The U.S. Fish and Wildlife Service (Service) is providing comments on the Mulqueeney Ranch Wind Repowering Project draft Subsequent Environmental Impact Report (SEIR). The mission of Service is to work with others to conserve, protect and enhance fish, wildlife, plants and their habitats for the continuing benefit of the American people. As part of our mission, we are charged with implementing various statutes, including the Bald and Golden Eagle Protection Act (16 U.S.C. 668-668d; Eagle Act) and the Migratory Bird Treaty Act (16 U.S.C. § 703 *et seq.*; MBTA). Our review and comments focus on our legal mandate and trust responsibility to maintain healthy bird populations for the benefit of the American public pursuant to the Eagle Act and MBTA. Our comments are consistent with Alameda County's (County) request that the Service provide technical assistance as a member of the Alameda County Altamont Pass Wind Resource Area (APWRA) Technical Assistance Committee (TAC), helping the County to address wind turbine impacts to eagles, birds, and bats.

The California Department of Fish and Wildlife (CDFW) received a Notice of Availability from the Alameda County Planning Department (County

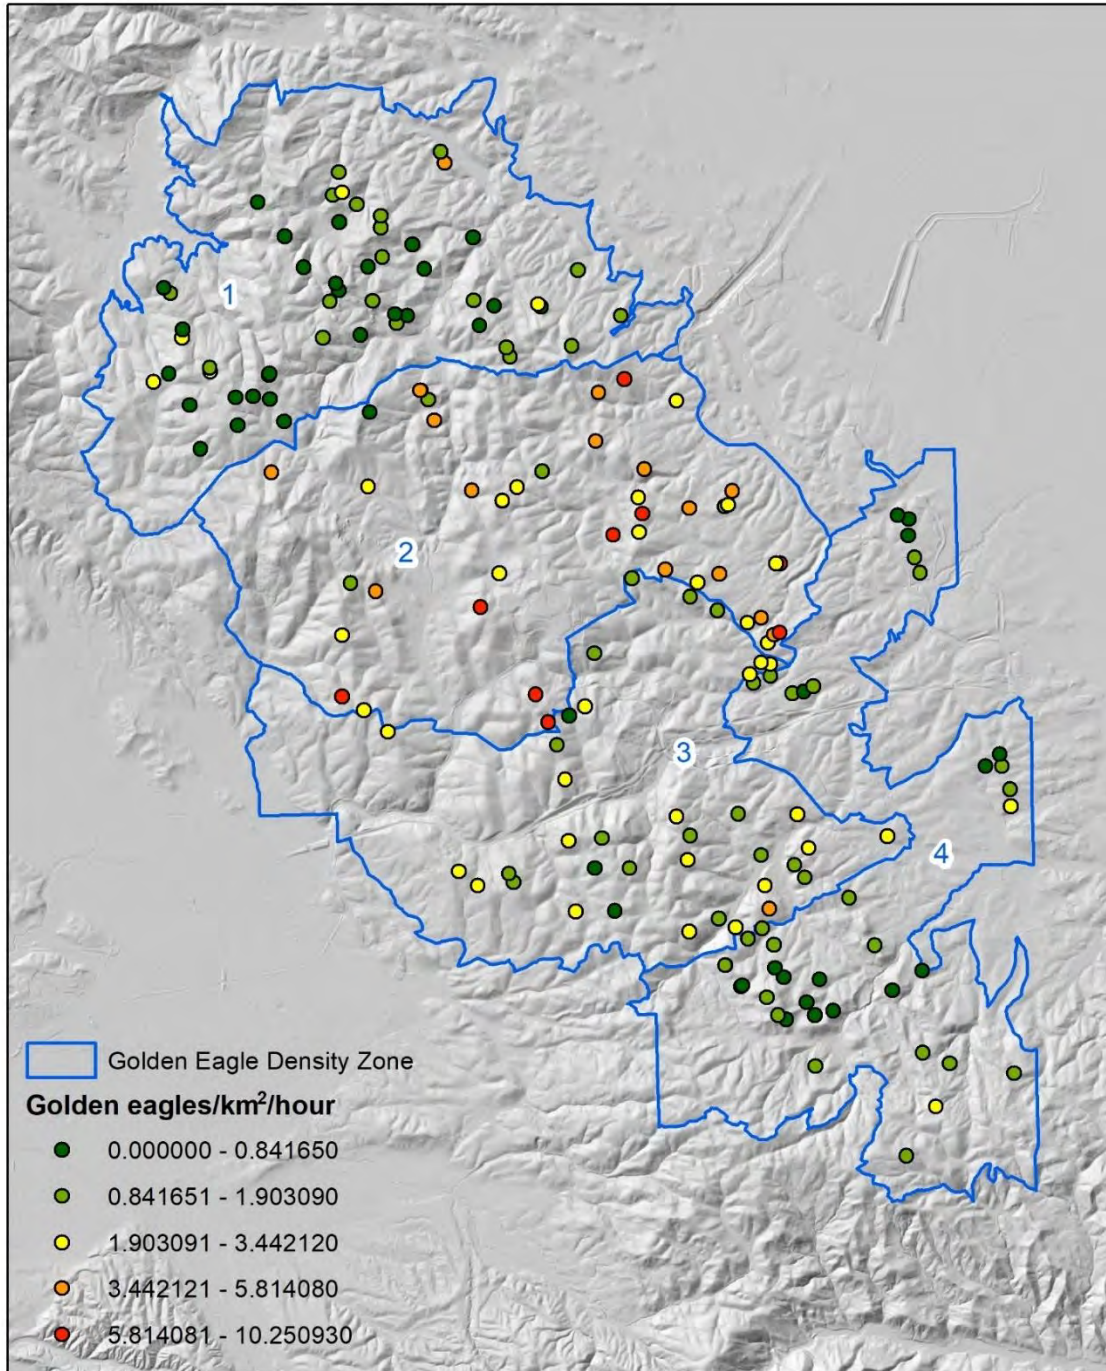
The DSEIR (p. 3.4-96) continues, **“The golden eagle, too, seems to be unusually abundant at the Golden Hills site.”** In fact, golden eagle abundance at Golden Hills was on the low side of moderate (see Figure 2, above).

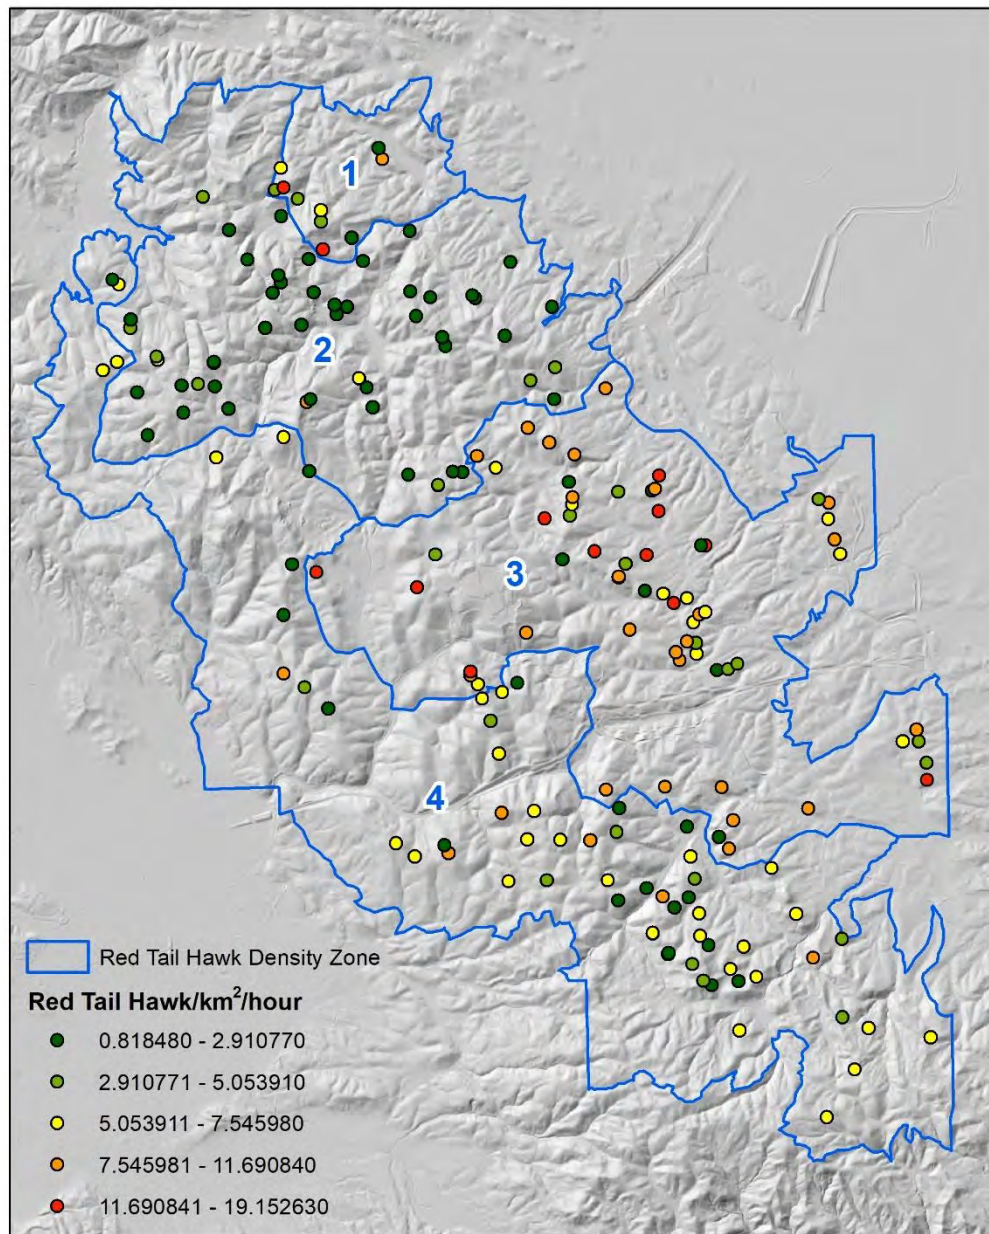
red-tailed hawks are exceptionally **abundant at this site.**” Again, **this conclusion is inaccurate** (see Figure 7, above). Red-tailed hawks were most abundant on the Elworthy Ranch, at Sand Hill, and at the northeast aspect of Buena Vista. Red-tailed hawk abundance at Golden Hills was low to moderate.

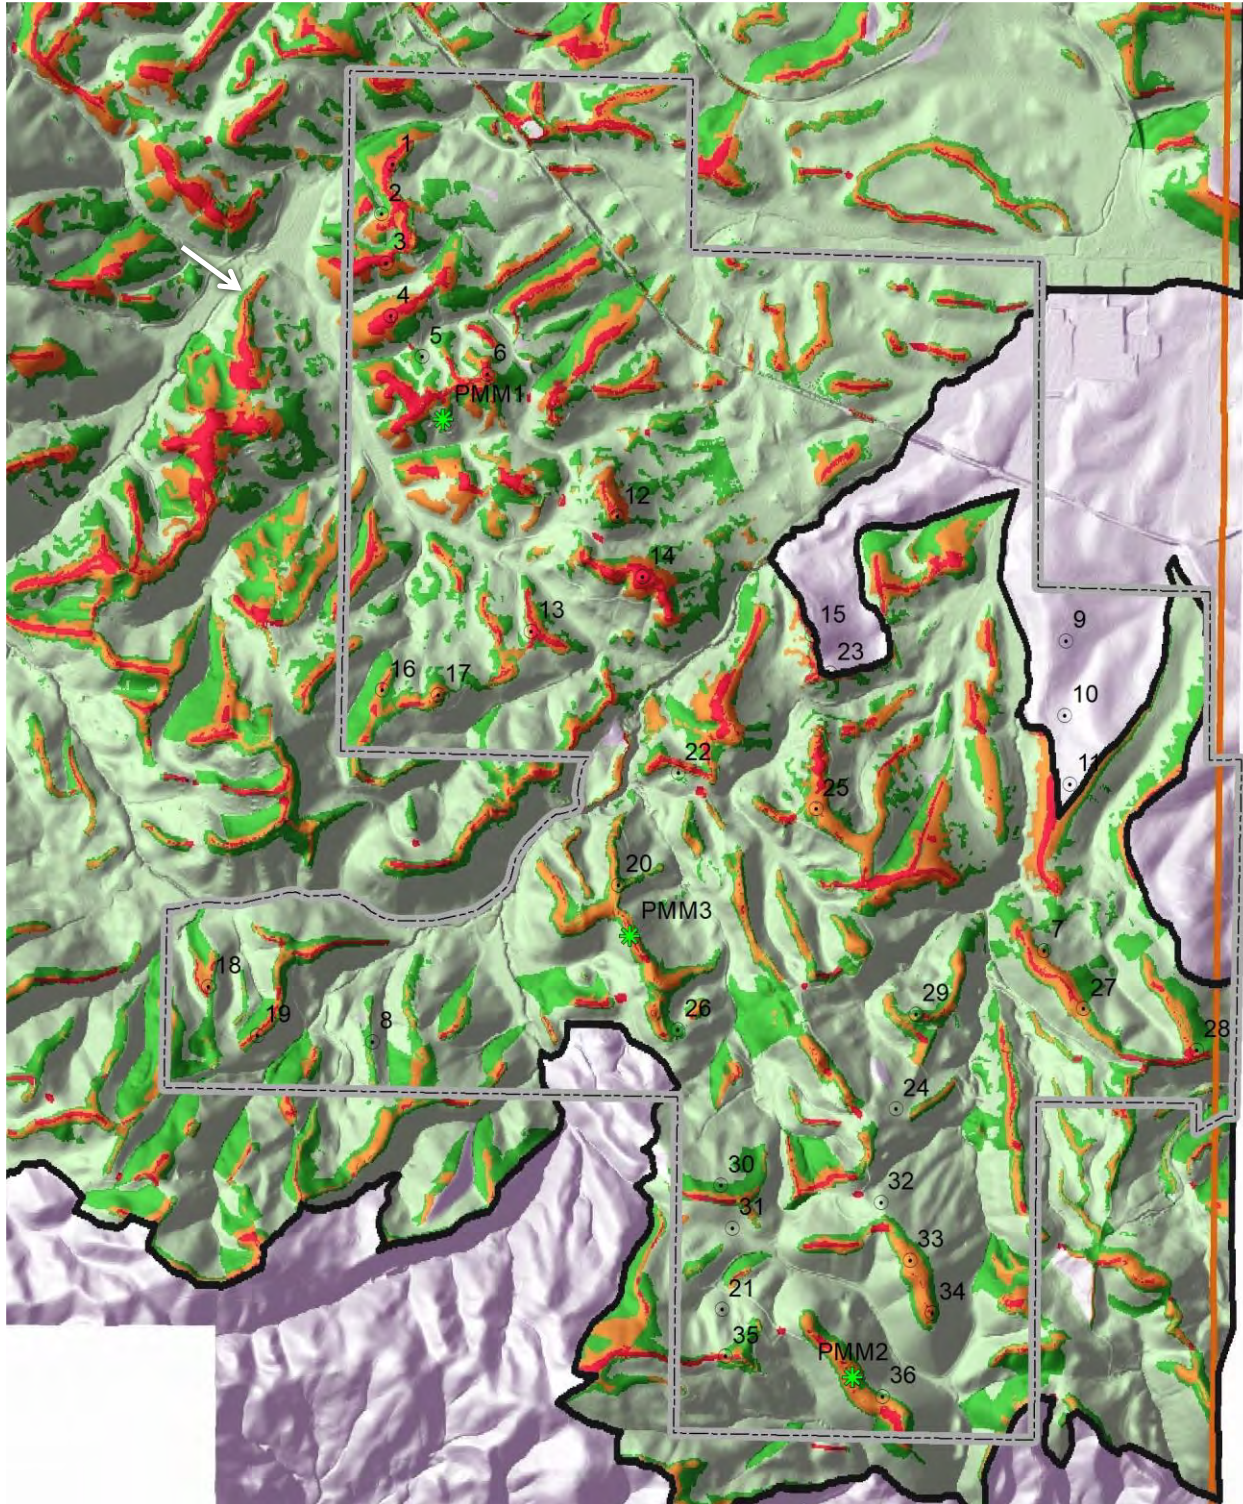
I asked my colleague, Lee Neher, to extend our latest collision hazard model for golden eagle into the proposed project area (Figure 16). An explanation of how this model was developed is provided in the micro-siting report we prepared for the Sand Hill project (Smallwood and Neher 2018). (Its descriptions in peer reviewed publications can be found in Smallwood and Neher 2009 and Smallwood et al. 2009, 2017). I also asked Mr. Neher to overlay our data on telemetered golden eagles onto the project area including the proposed wind turbine layout (Figures 17 to 22). He selected the positions of 11 GPS-telemetered golden eagles that had crossed some portion of the Mulqueeny Ranch project area within 200 m of the ground. We chose to filter out data above 200 m because the maximum turbine height would likely be 154 m. Finally, I examined the proposed turbine locations for hazards posed by the terrain setting and by likely changes to the local terrain due to construction grading. I used Google Earth to examine proposed turbine locations, but it helped that I was personally familiar with the project area.

The white arrow in Figure 16 points to the site of Golden Hills turbine 11 – a site I advocated against during the micro-siting process (Smallwood and Neher 2015). Note the red polygon overlapping the site indicated by the white arrow. Red denoted the model-predicted hazard class of 4, where 4 was the highest hazard of the 4 classes, 1 through 4. But my micro-siting recommendations were not based entirely on the model predictions. I knew the models were limited to the spatial information we were able to quantify and use in GIS, and I had experience that just could not be input to the model. I therefore personally visited each site to assess the terrain setting, and I assembled a history of collision mortality associated with old-generation wind turbines at the site. I also relied on experience with grading effects at Vasco Winds, and on the behavior surveys I had been performing in the area at the time. I was aware of considerable social drama that takes place between golden eagles around where turbine 11 was proposed (Photo 29). **I advised my client, "Pretty much the entire slope has been identified as hazardous to eagles, so this site was of concern. The site is low, near the valley, and gets a lot of eagle traffic. There is no move within 150 m that would lessen the hazard level." My client installed turbine 11 there anyway, and it soon proved hazardous to golden eagles.**

Figure 17. Positions of 11 GPS-telemetered golden eagles in flight within 200 m of the ground, selected for having crossed the Mulqueoney Ranch wind project between 2013 and 2019.

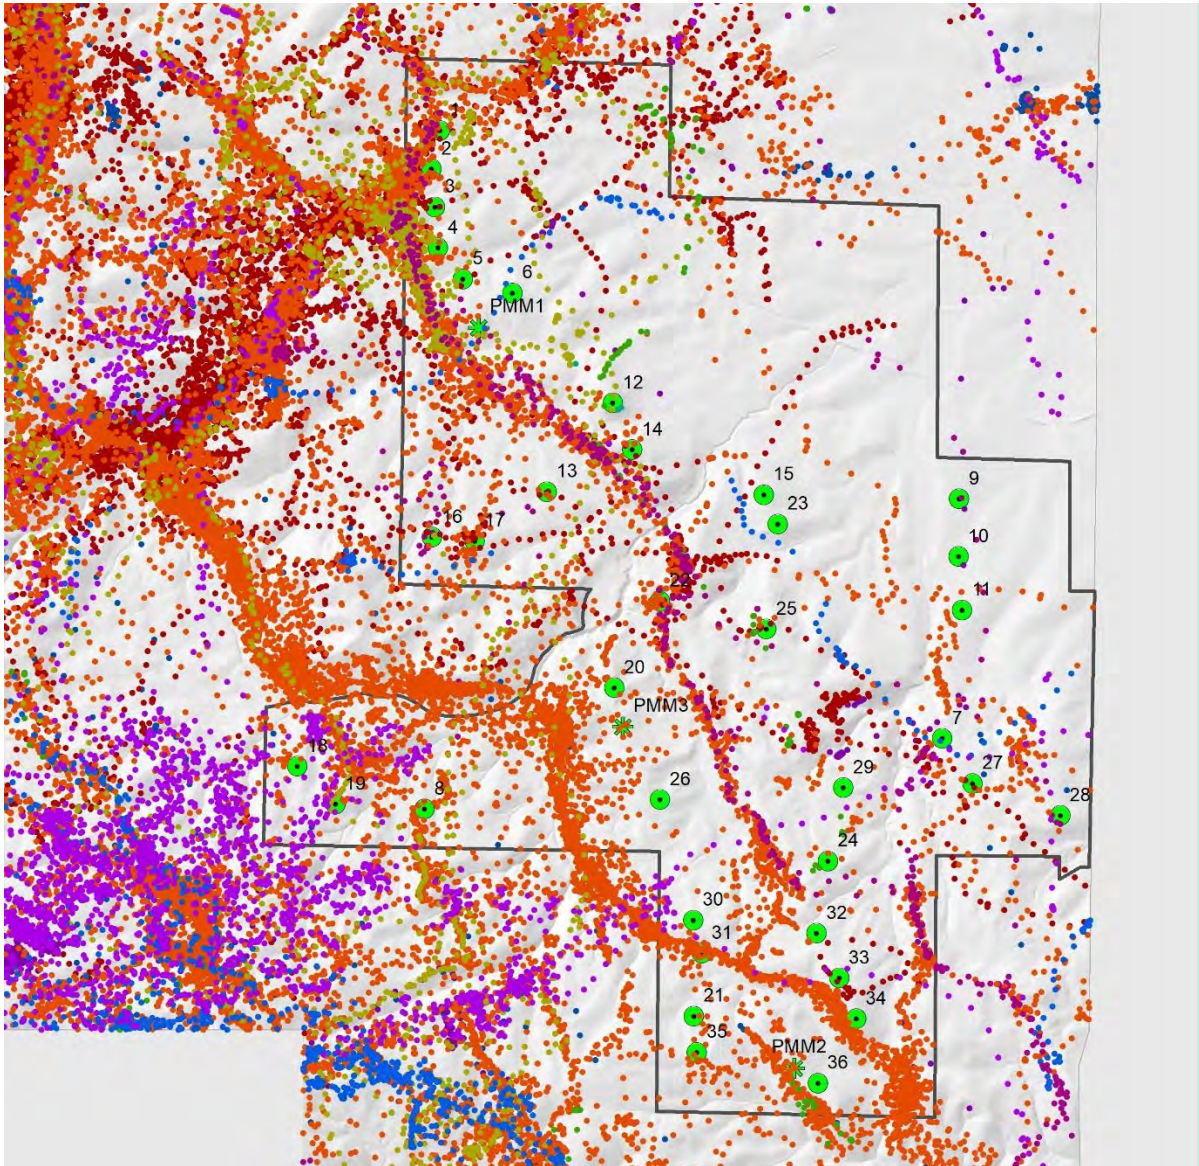
In fact, as is obvious in Figures 17 and 18, Mulqueeney sites 1 through 5 are heavily used by golden eagles. The traffic of our telemetered golden eagles is so densely packed along **sites 1 through 5 that the pattern forms what looks like one of several 'rivers.'** These rivers of activity align along valleys and along the southwest faces of ridges, often spilling over the ridges themselves (Figures 17 through 22). If the eagles were to stay within predictable lanes, micro-siting would be easier, but social demands pull them from their lanes. After watching golden eagle behaviors for hundreds of hours, it became clear to me that no eagle flight in the APWRA was random. I became more aware that unless golden eagles were contouring or hovering in obvious foraging patterns, they were flying towards targets such as a perch site or more often another golden eagle or a bald eagle or red-tailed hawk. Golden eagles can see more from the sky than any of us observers can see from stations on the ground, but I learned to search the distant areas to where eagles were headed to often see the eagle that I otherwise would not have detected. Or alternatively, I learned to backtrack to where a young golden eagle was headed from to detect the older golden eagle that had displaced it.

Figure 18. Positions of 11 GPS-telemetered golden eagles in flight within 200 m of the ground in the northwest portion of the Mulqueeney Ranch wind project between 2013 and 2019.

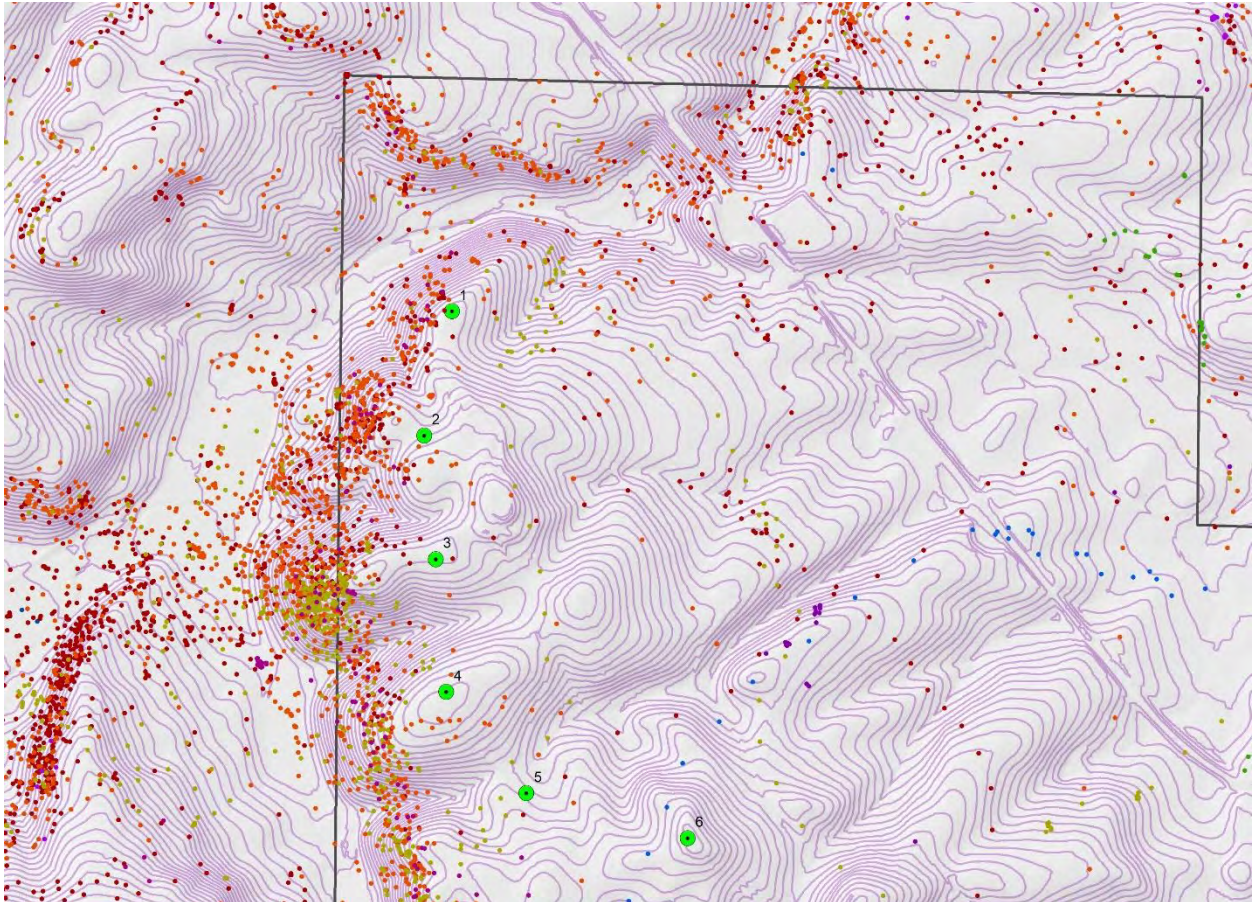
Patterns in the golden eagle telemetry data make clear that not all candidate turbine sites are equal in the collision risk they pose. In Figure 17 it is obvious that sites 9 and 10 get much less traffic than do sites 1 through 5. However, these data reflect only what the 11 telemetered golden eagles did between 2013 and 2019. Many more golden eagles used the APWRA than these 11 eagles. My visual-scan behavior observations included many more of the other golden eagles, so they contributed to my understanding of patterns of eagle activity in the APWRA. For example, Figure 18 does not depict a strong pattern I observed many times during behavior surveys, and that was low, east-west flights along the north side of the east-west ridgeline on which proposed
